Service Bulletin

No.: MZ08-051

Model: AV8003

Subject: Change of the XLR connector.

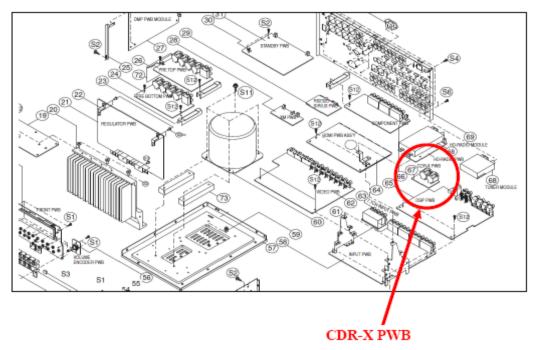
Symptom: Due to the XLR cable (male connector) varying in quality and also to wear, some XLR female jacks manufactured by Dongbo Industries Ltd. are not tight enough to lock when connectors are inserted.

Solution: The supplier of the POS NO. JK13/JK14 (CDR-X PWB) XLR female connector will be switched to Jyetai Precision Industrial Co., Ltd.

Ref #	FORMER		NEW	
	Description	Part Number	Description	Part Number
JK13,	XLR JACK	943646000870S	XLR JACK	00D2051254007
JK14	Dongbo		JYETAI Ltd.	
	Industries Ltd.
